**SUNDRY NOTICES AND REPORTS ON WELLS**  
*Do not use this form for proposals to drill or to re-enter an abandoned well. Use form 3160-3 (APD) for such proposals.*

## **Rincon Unit #290** **Current**

## Rincon Unit #290

Re: Permanent Abandonment  
Well: Rincon Unit 290

### Proposed P&A

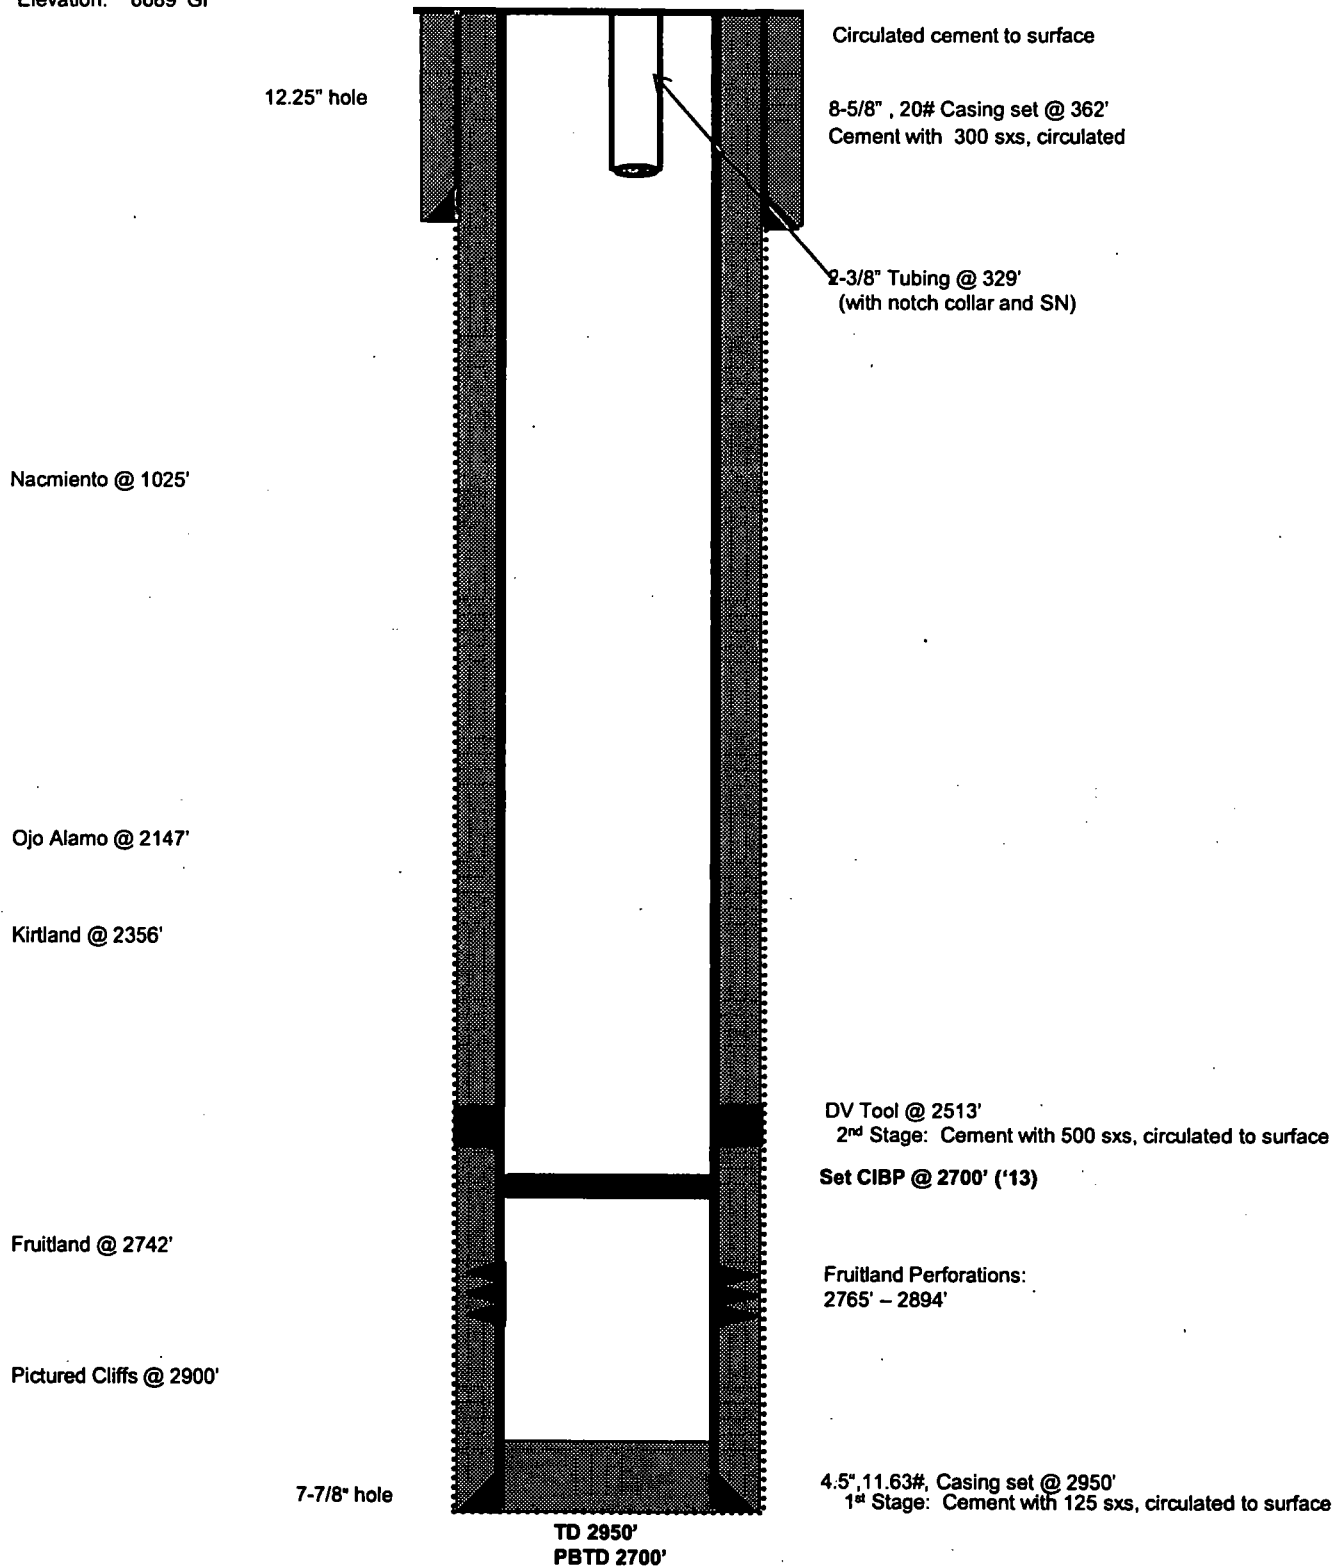
1. Plugging operations authorized are subject to the attached "General Requirements for Permanent Abandonment of Wells on Federal and Indian Lease."
2. Farmington Office is to be notified at least 24 hours before the plugging operations commence (505) 564-7750.
3. The following modifications to your plugging program are to be made:
  - a) Set plug #2 (2308 – 1976) ft. to cover the Kirtland and Ojo Alamo tops. BLM picks top of Kirtland at 2258 ft. BLM picks top of Ojo Alamo at 2026 ft.
  - b) Set plug #3 (993 – 893) ft. to cover the Nacimiento top. BLM picks top of Nacimiento at 943 ft.

You are also required to place cement excesses per 4.2 and 4.4 of the attached General Requirements.
